MEMO

To: Kristopher Byrd, Well Construction and Compliance Section Manager
From: Joel Jeffery, Well Construction Program Coordinator
Subject: Review of Limited License Applications LL-1726 1728
Date: August 30, 2018

Groundwater Application Review Summary Form

TO: Water Rights Section Date 08/28/2018
 FROM: Groundwater Section Darrick E. Boschmann
Reviewer's Name
 SUBJECT: Application LL1726/LL1728 Supersedes review of N.A.
Date of Review(s)

Figure 2: Hydrograph for LAKE 1633.

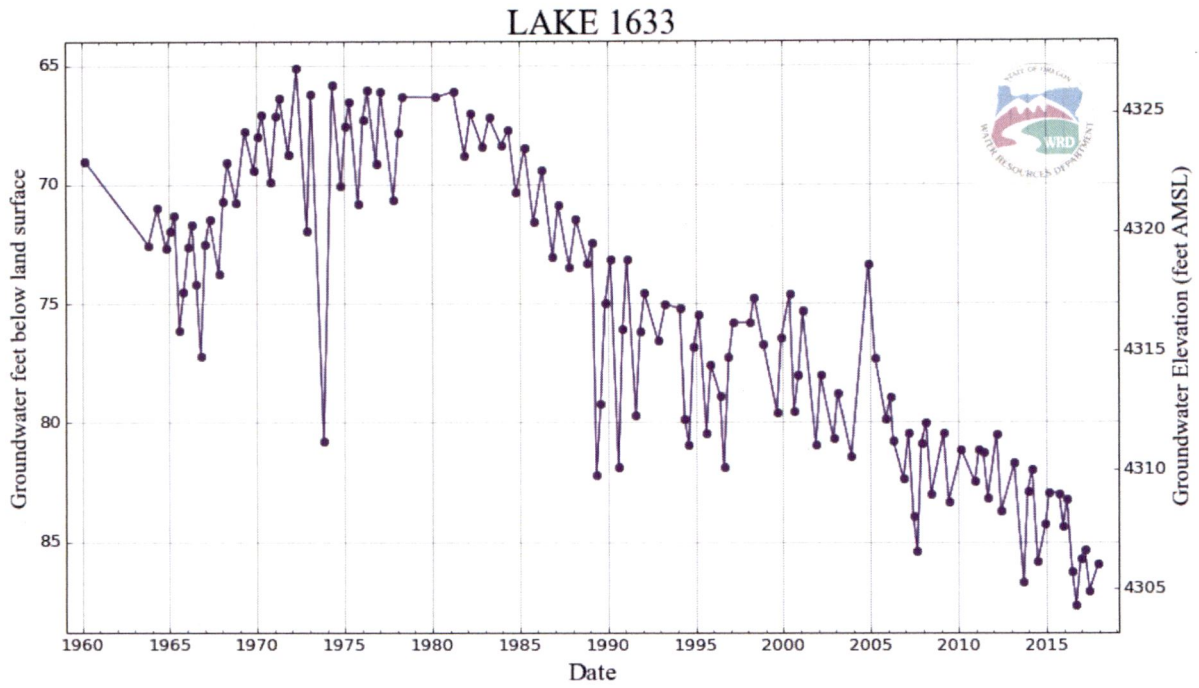
The nearest state observation well to the proposed location is State Observation Well 374 (LAKE 1633) located ~1.5 miles to the northeast which has a period of record from 1963 to 2017. The long term annual groundwater level trend in this well indicates an overall year-year water level decline of about 19 feet from 1980 to 2017, or roughly 0.5 feet per year since 1980. Formation descriptions on the well log for LAKE 1633 indicate the well is completed in the basin fill sediments.

Figure 3: Reported permit condition water level data for LAKE 52683.

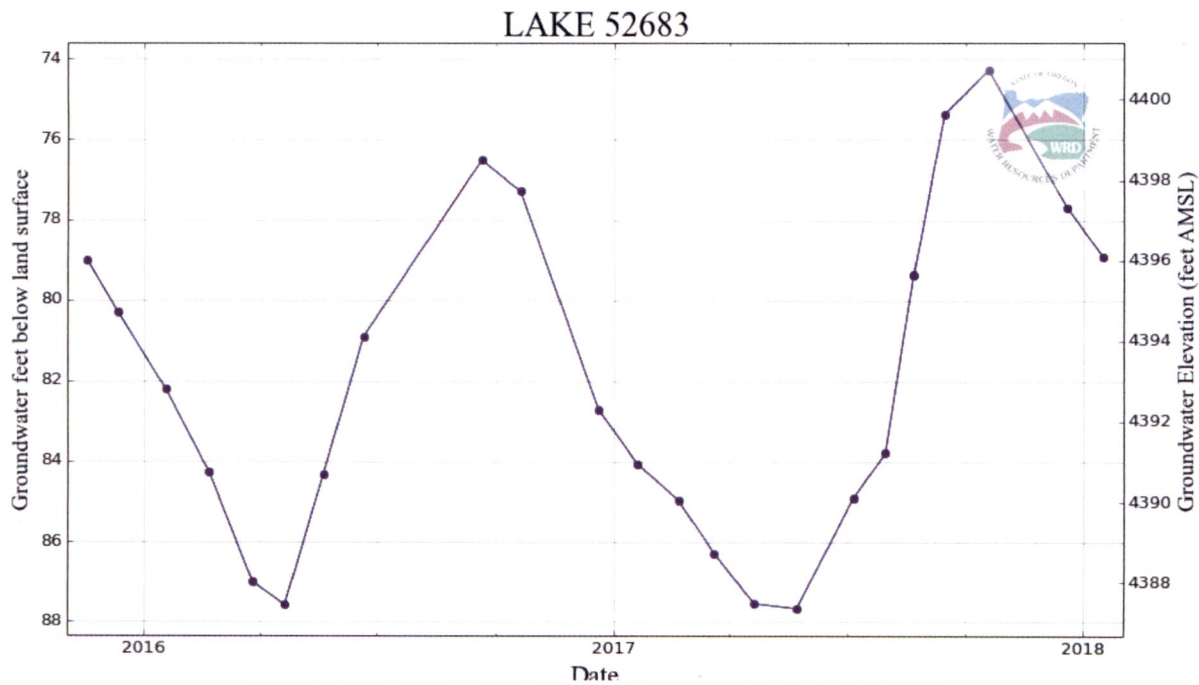
Observation well LAKE 52683 (permit condition obs well under permit G-17434; 380ft TD/115°F) located within the project area has a period of record from 2015 to 2018. No long term annual groundwater level trend can be identified in this well due to the short period of record; however there are no immediate signs of water level decline. Formation descriptions on the well log for LAKE 52683 indicate the well is completed in the basin fill sediments.

Figure 4: Reported permit condition water level data for LAKE 1628.

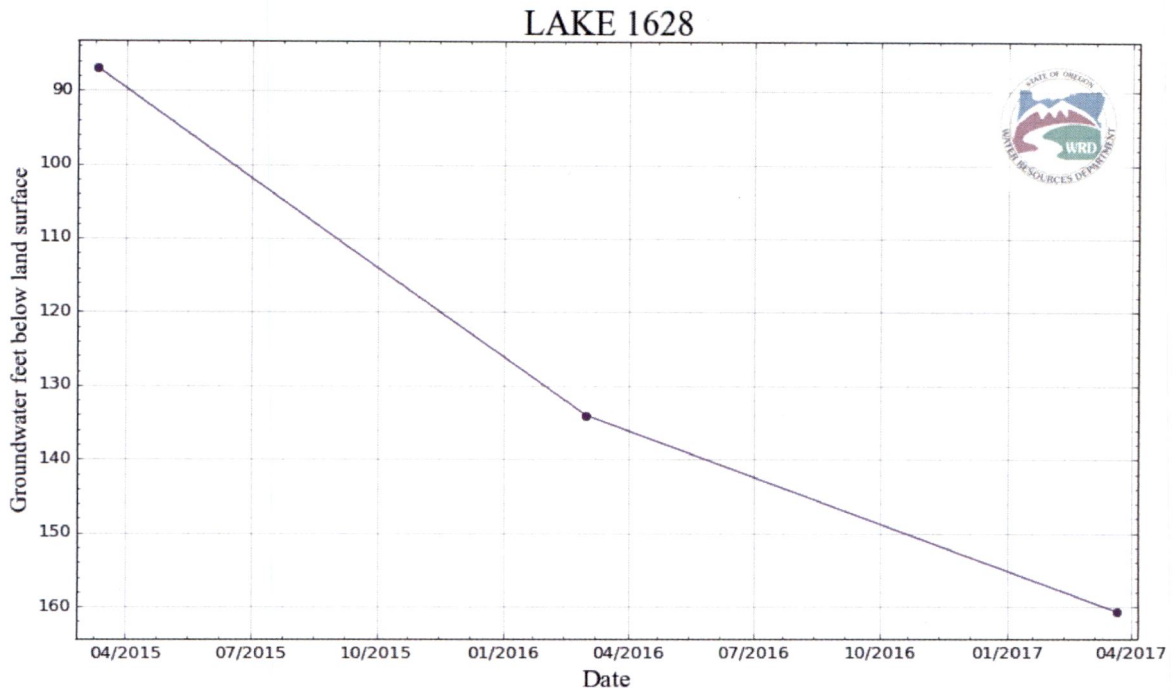
March static water levels reported to the department under the permit condition program for LAKE 1628 (“Little Hot Well”; 432 ft TD/175°F) indicate a 73 foot water level decline over the period 3/2015 – 30/2017. March static water levels reported to the department under the permit condition program for LAKE 52506 (“SVE#4” industrial use/cooling water; 378 ft

It is clear from the supplemental data that the “static” water level reported to the department for 03/01/2016 and 03/22/2017 for LAKE 1628 was affected by a recent period of pumping either in that well, or in LAKE 52506, or possibly both, and that the water level reported represents a pumping or recovery/rising level, rather than a true static water level which could be directly compared to the March level from the previous year. Due to the year-round pumping/recovery cycles at this well it is difficult to determine whether or not any year-to-year water level declines are occurring, however since regular pumping began in 2015 the well has never fully recovered to its pre-2015 static water levels, and the full record does seem to indicate that declines may be occurring.

Figure 5: Reported permit condition water level data for LAKE 52506.

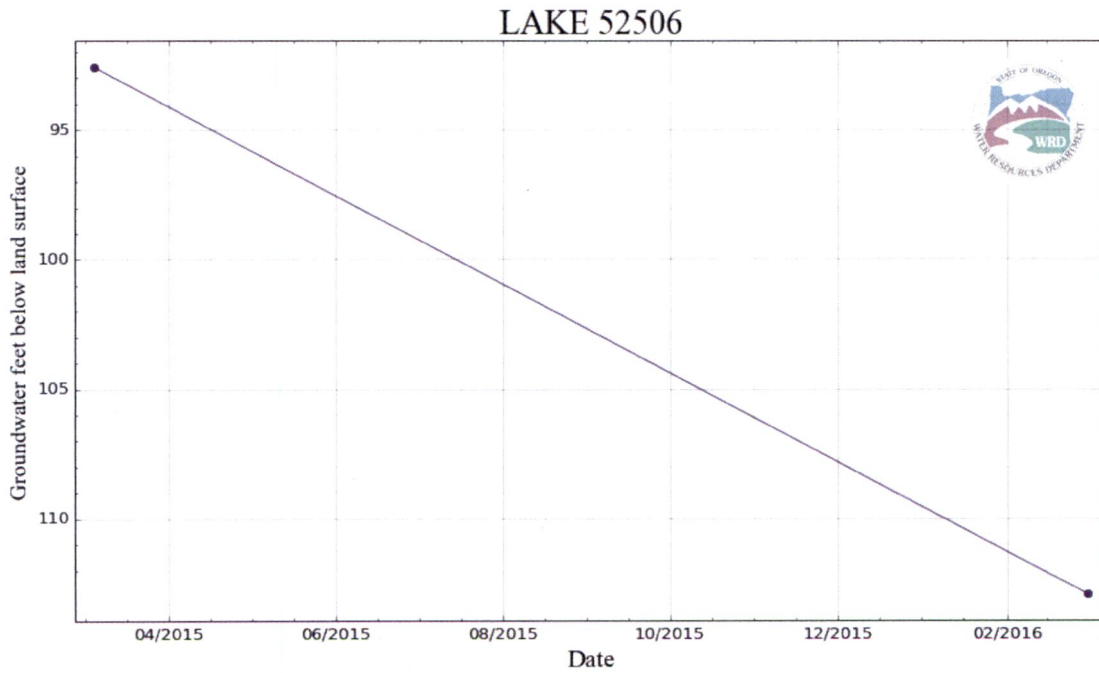
It is clear from the supplemental data that the “static” water level reported to the department for 03/01/2016 for LAKE 52506 was affected by a recent period of pumping in that well; and that the water level reported represents a pumping or recovery/rising level, rather than a true static water level which could be directly compared to the March level from the previous year. The period of record for LAKE 52506 provided in the supplemental data covers 05/12/2014 – 01/16/2018. Due to the year-round pumping/recovery cycles at this well it is difficult to determine whether or not any year-to-year water level declines are occurring; although from October 2014 to October 2017 (two periods for which there appears to be no direct pumping influence), the record does indicate approximately 7-8 feet of overall decline; or approximately 2.5 ft/yr.

Figure 6: Supplemental data provided by the applicant - LAKE 1628.

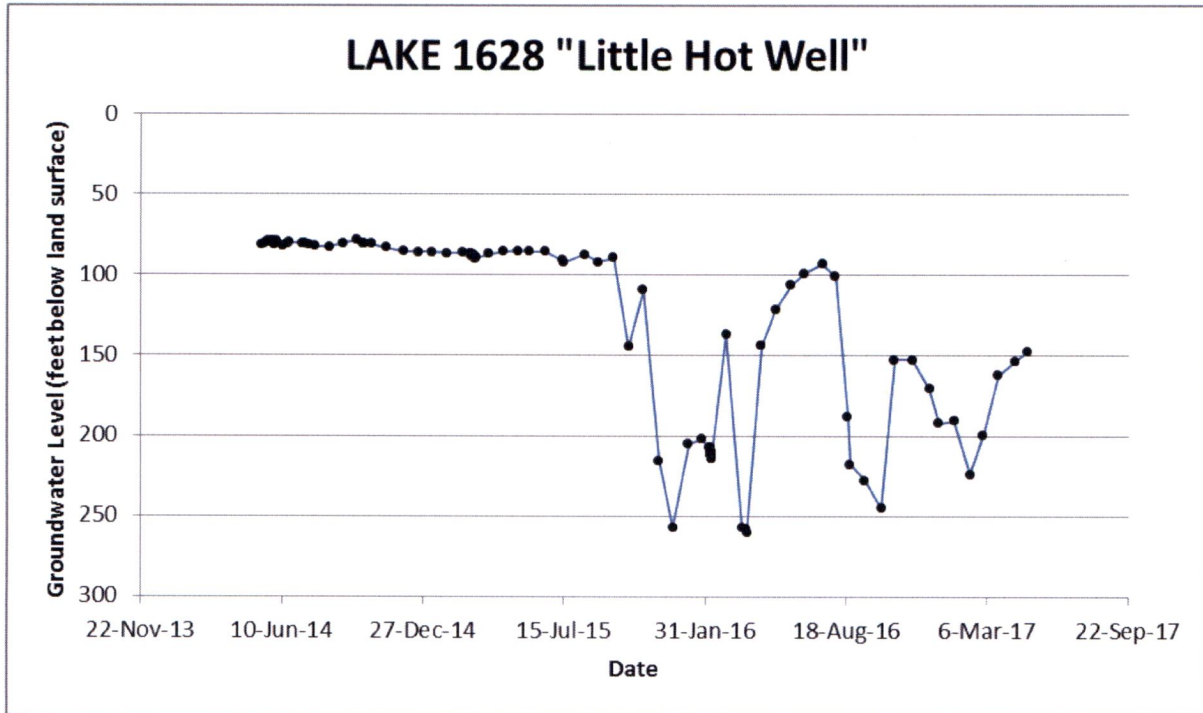
Miscellaneous water level data made available to this reviewer by the applicant supplement the data available from the OWRD GWIS database. Review of these data presents an alternate interpretation from that made based on the permit condition program data alone for LAKE 1628 and LAKE 52506.

Figure 8: Supplemental data provided by the applicant - LAKE 52530.

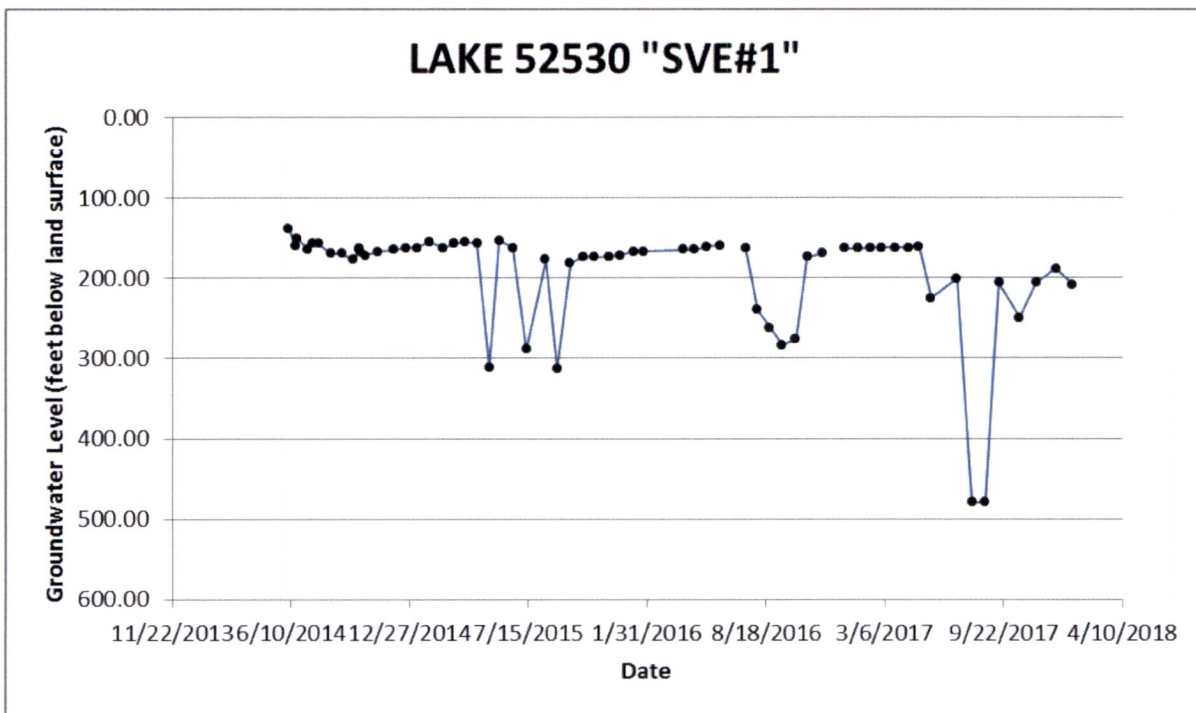
Proposed production well LAKE 52530 (SVE#1) has a period of record from 6/6/2014 to 1/16/2018. Due to the year-round pumping/recovery cycles at this well it is difficult to determine whether or not any year-to-year water level declines are occurring, however there are no apparent signs of significant water level declines.

Figure 9: Supplemental data provided by the applicant - LAKE 52529.

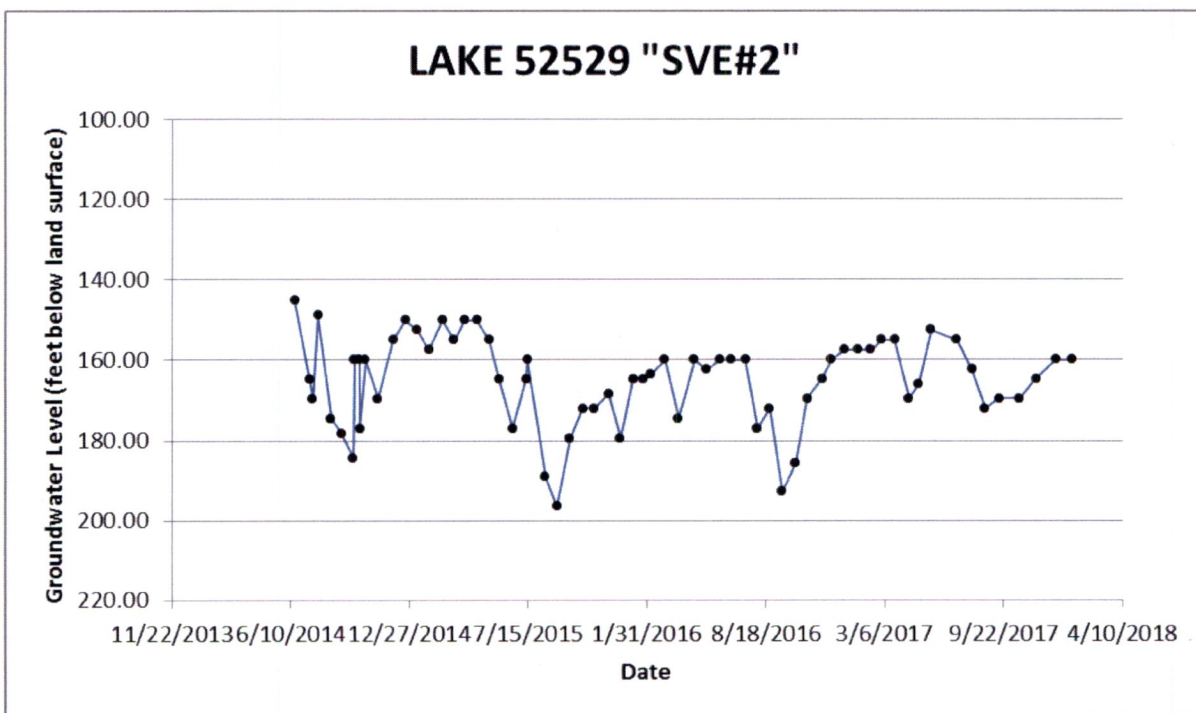
Proposed production well LAKE 52529 (SVE#2) has a period of record from 6/17/2014 to 1/16/2018. Due to the year-round pumping/recovery cycles at this well it is difficult to determine whether or not any year-to-year water level declines are occurring, however there are no apparent signs of significant water level declines.

Figure 10: Supplemental data provided by the applicant - LAKE 1638.

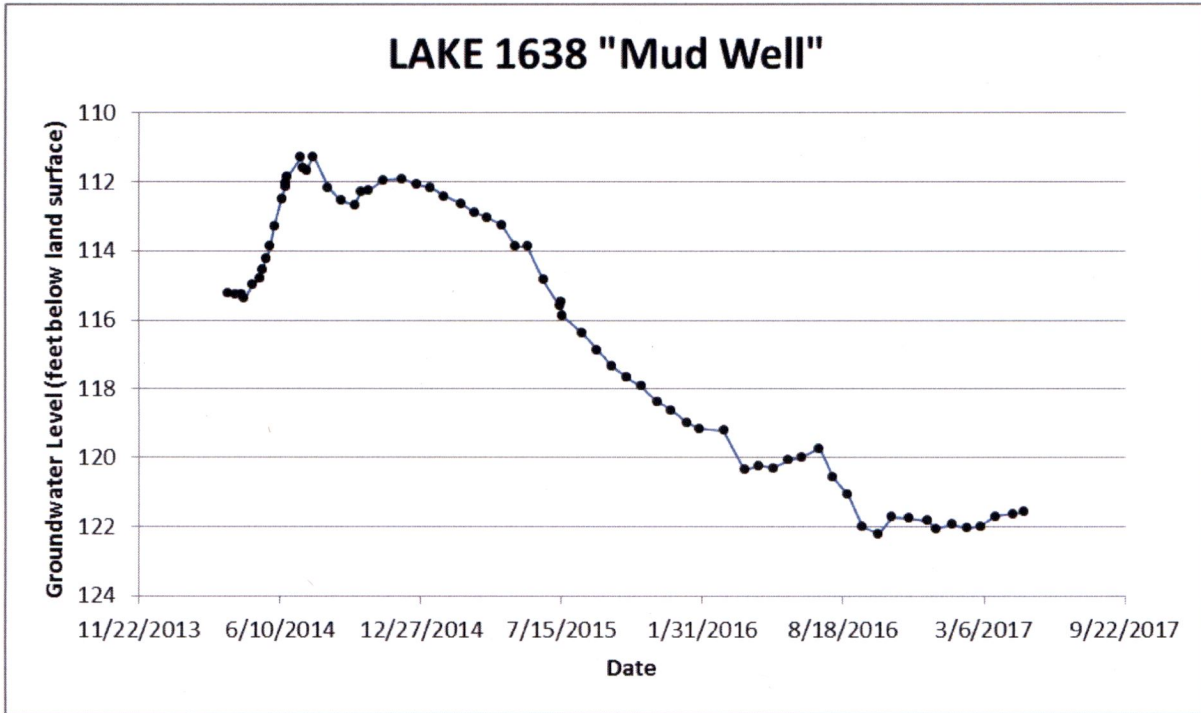
LAKE 1638 (“Mud Well”; unused irrigation well/livestock?; 775 ft TD/120°F) has a period of record from 3/28/2014 to 5/2/2017. The hydrograph for this reportedly unused irrigation well shows a clear and consistent decline trend from 2014 through spring of 2017 of approximately 6-10 feet over the period of record; or approximately 2 – 3.3 ft/yr. Formation descriptions on the well log for LAKE 1638 indicate the well is completed in the basin fill sediments.

Figure 11: Supplemental data provided by the applicant - LAKE 1625.

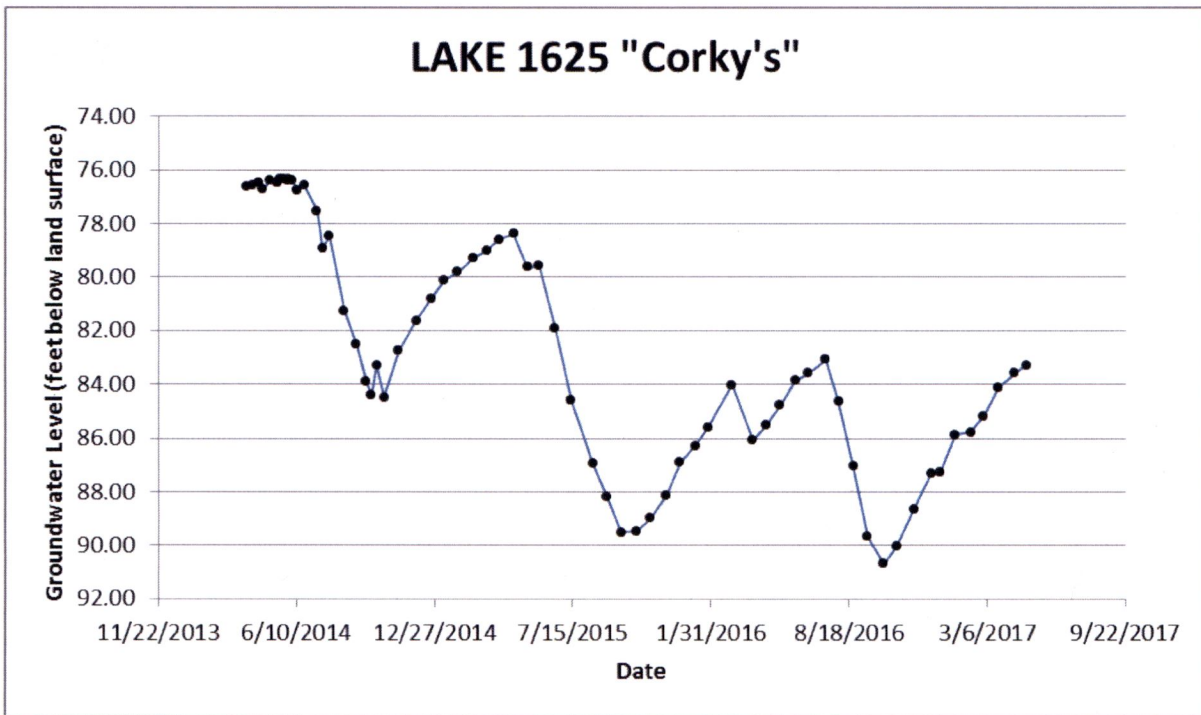
LAKE 1625 (“Corky’s”; unused irrigation well; 610 ft TD/175°F) has a period of record from 3/28/2014 to 5/2/2017. The hydrograph for this reportedly unused irrigation well shows a clear and consistent decline trend from 2014 through spring of 2017 of approximately 6-7 feet over the period of record; or approximately 2 ft/yr. Formation descriptions on the well log for LAKE 1625 indicate the well is completed in the basin fill sediments.

Figure 12: Supplemental data provided by the applicant - LAKE 1637.

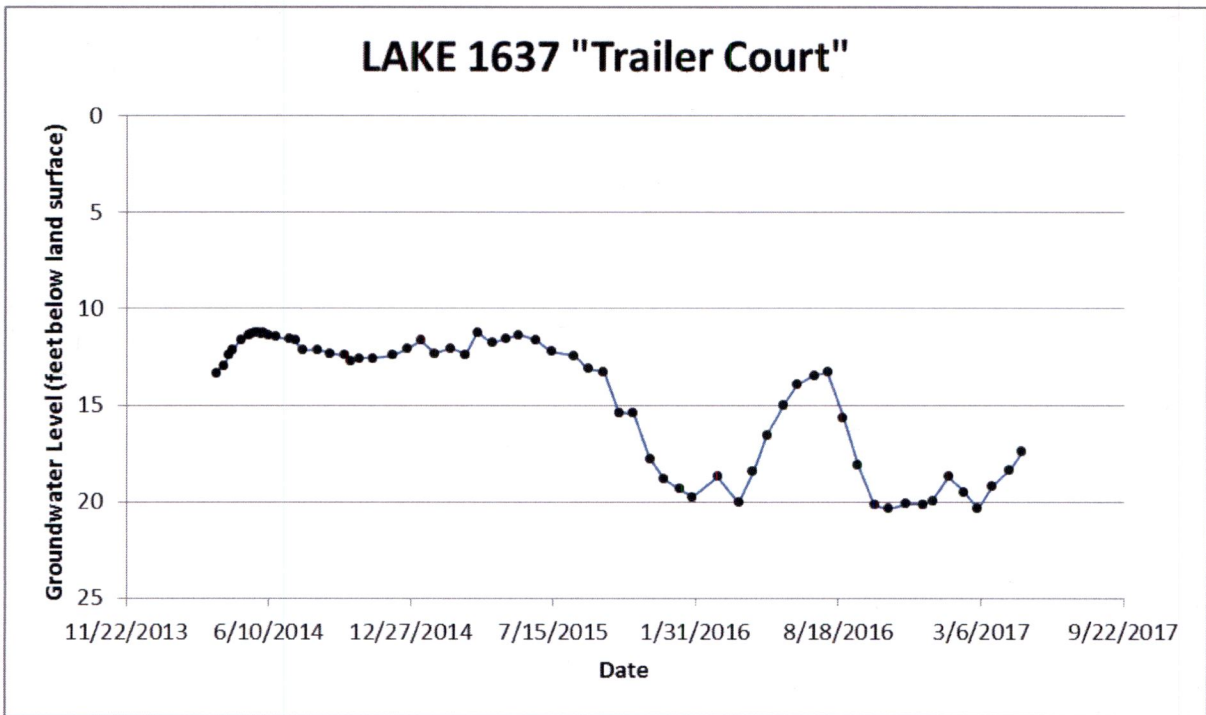
LAKE 1637 (“Trailer Court”; livestock; 153 ft TD/~75°F) has a period of record from 3/28/2014 to 5/2/2017. Due to the year-round pumping/recovery cycles at this well it is difficult to determine whether or not any year-to-year water level declines are occurring. Formation descriptions on the well log for LAKE 1637 indicate the well is completed in the volcanic rock unit.

Figure 13: Supplemental data provided by the applicant - LAKE 4278.

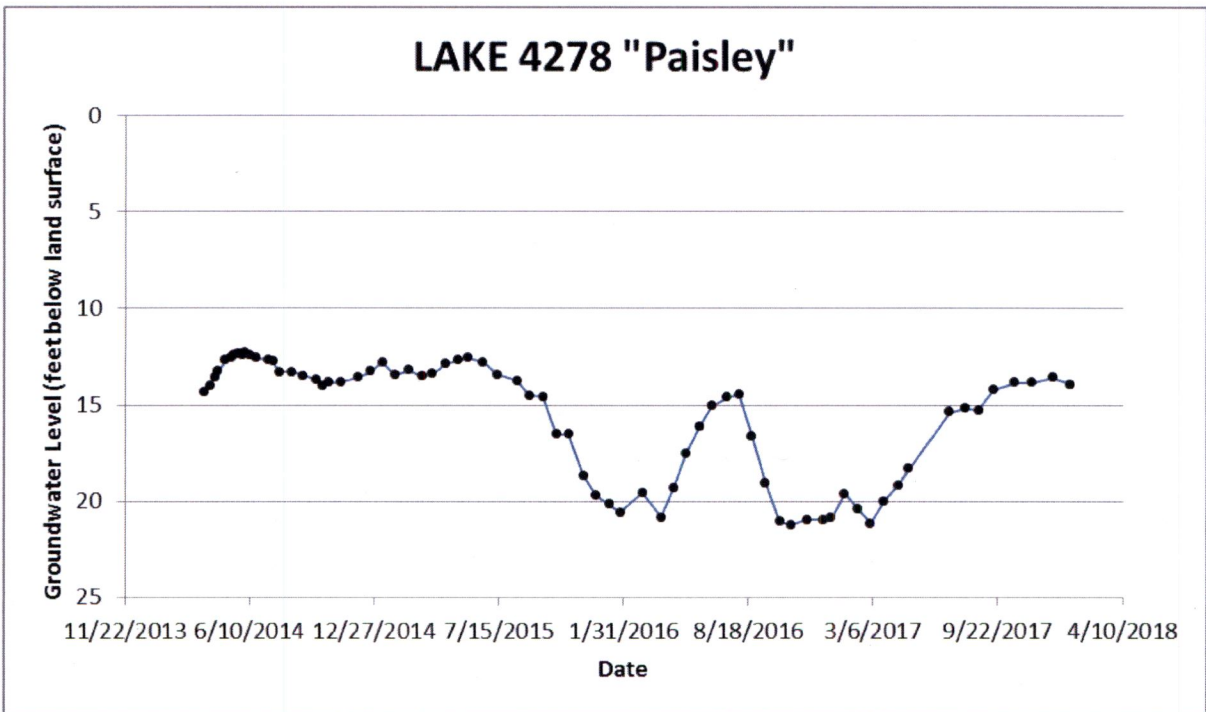
LAKE 4278 (“Paisley”; unused; 515 ft TD/115°F) has a period of record from 3/28/2014 to 1/16/2018. The hydrograph for this well does not indicate any apparent signs of significant water level declines. Formation descriptions on the well log for LAKE 4278 indicate the well is completed in the volcanic rock unit.
